**MONTANA DEPARTMENT OF ENVIRONMENTAL QUALITY  
PERMITTING AND COMPLIANCE DIVISION**

**RECORD OF DECISION**

**TVX Mineral Hill, Inc.**

**Consolidated Closure Plan Modifications**

Figure 3-4  
Anticipated TSF Biological Treatment System Performance

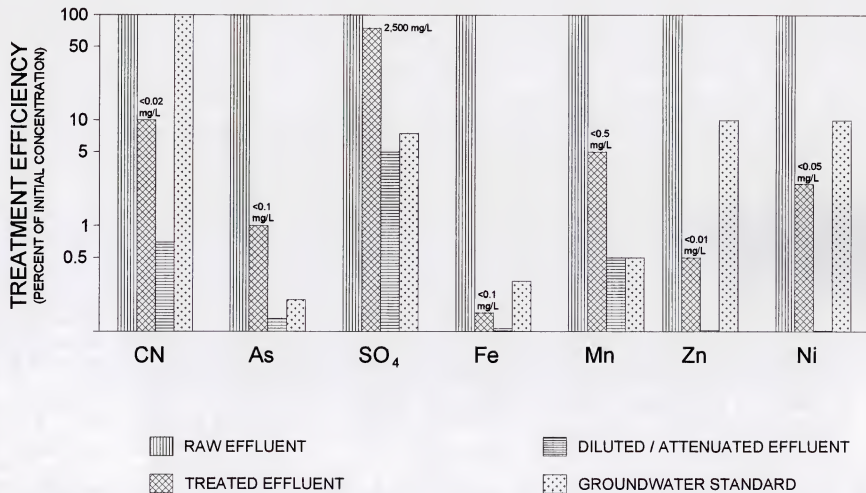
Second: Looking at Table 3-1 and Figure 3-4 raises questions about the effectiveness of the whole TSF treatment system in the removal of sulfates. SO<sub>4</sub> can easily turn into sulfuric acid with consequent pH problems in any receiving water and/or metals leaching. There seems to be very little room between the predicted performance of the system as revealed in these tables and compliance with water quality standards. What assurance does the department and the public have that any effluent from the HDS will consistently meet standards?
